STATE OF CONNECTICUT SITING COUNCIL

**PETITION OF LSE PICTOR LLC
FOR A DECLARATORY RULING
THAT NO CERTIFICATE OF ENVIRONMENTAL
COMPATIBILITY AND PUBLIC NEED IS
REQUIRED FOR THE CONSTRUCTION,
OPERATION, AND MAINTENANCE OF
A 1.99 MW AC SOLAR PHOTOVOLTAIC
FACILITY IN WINCHESTER, CONNECTICUT**

PETITION NO. 1398A

**PETITIONER LSE PICTOR LLC'S RESPONSES TO SITING COUNCIL INTERROGATORIES
DATED MARCH 23, 2021 AND SUPPLEMENTAL SUBMISSION**

Figure 1 **Wetland and Vernal Pool
Resources**

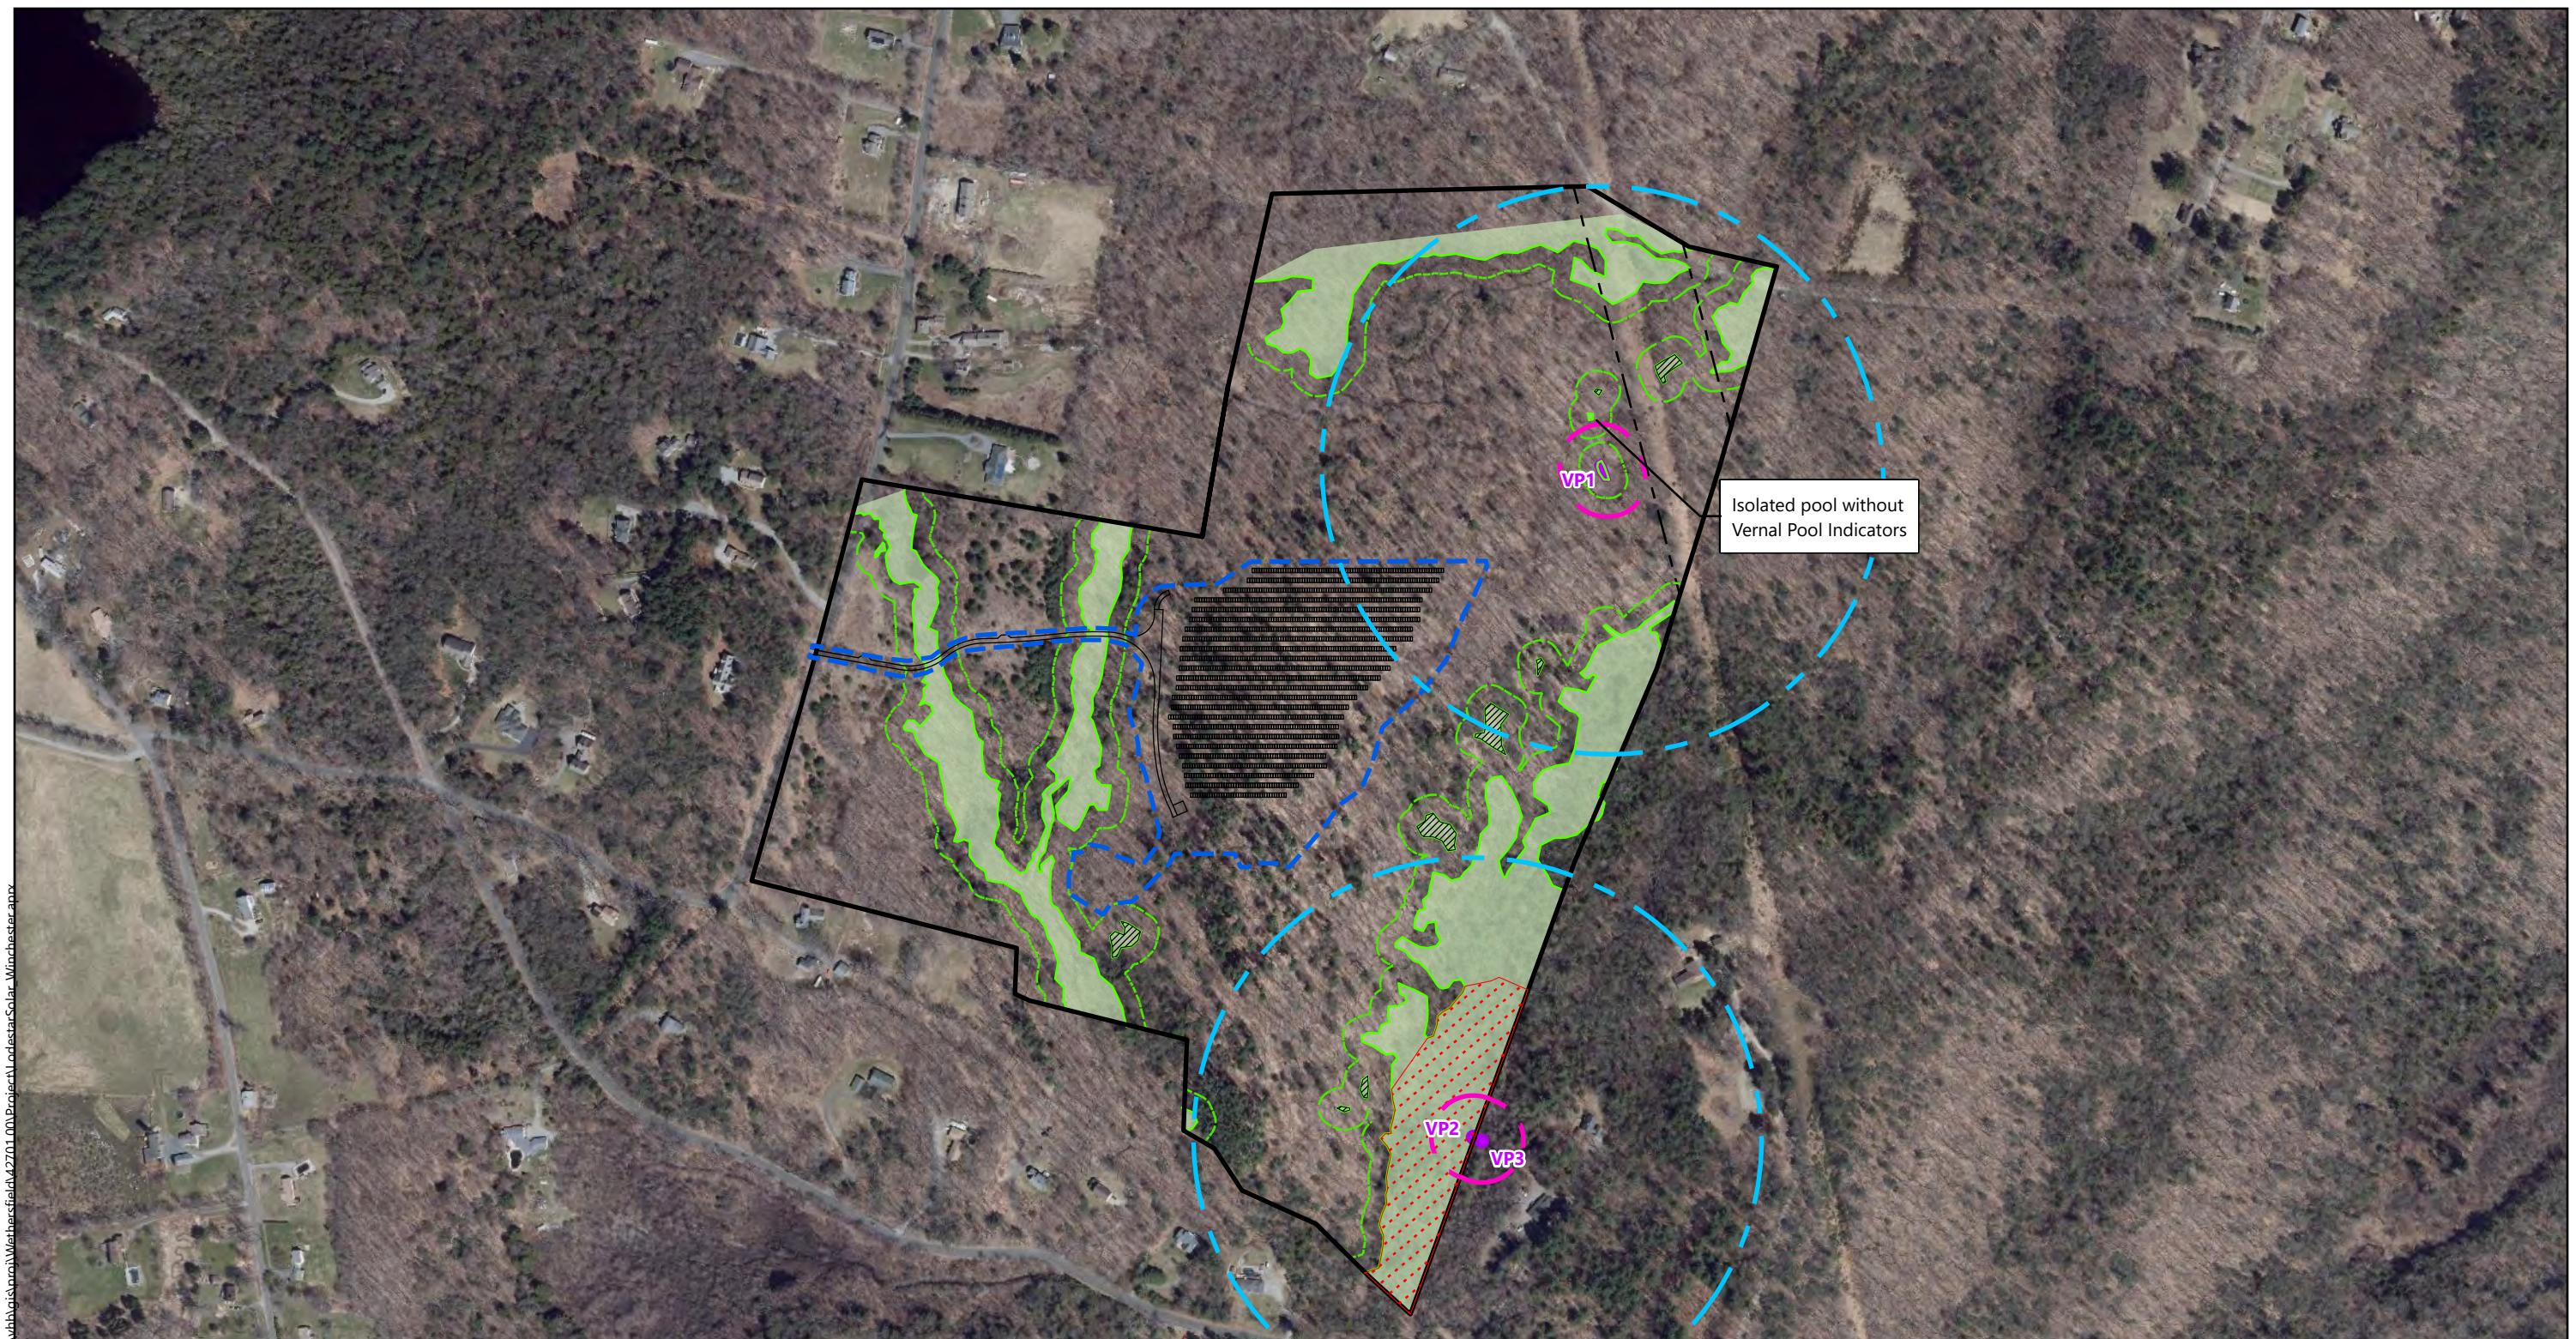
5. *The July 5, 2005 Wetland letter from Penelope C. Sharp mentions the potential for vernal pools with the red maple swamp in the eastern portion of the property. Was the red maple swamp surveyed for the presence of vernal pools? If so, submit survey results. If not, why not?*

RESPONSE: The Petitioner conducted a vernal pool investigation of the Site on April 1, 2021, a copy of which is attached hereto as Exhibit 3. As can be seen from Exhibit 3, four (4) areas of the Site were found to support breeding by obligate vernal species. However, only three (3) of those areas exhibited physical and biological vernal pool indicators. Two cryptic vernal pools determined as tier III breeding areas were identified specifically within the red maple shrub swamp. As noted in Exhibit 3, the vernal pools identified within the red maple swamp has sub-optimal breeding conditions and breeding attempts within areas that may contain fish or within areas with insufficient water depths are unlikely to be successful. Due to the location of the two (2) vernal pools within the red maple swamp—on the eastern property boundary, no portion of the Project will have any impact on the vernal pool or any portion of the vernal pool envelopes nor the 750-foot Critical Terrestrial Habitat (“CTH”) associated with those two (2) cryptic vernal pools.

The remaining vernal pool, Vernal Pool 1, was already noted and assumed to be a vernal pool on Petitioner’s Site plans and Wetland Impact Assessment prepared by VHB. Therefore, confirmation of this pool does not require any changes to the Site Plan. The Project will have an impact on 5% of the CTH, which is well-within best management practices.
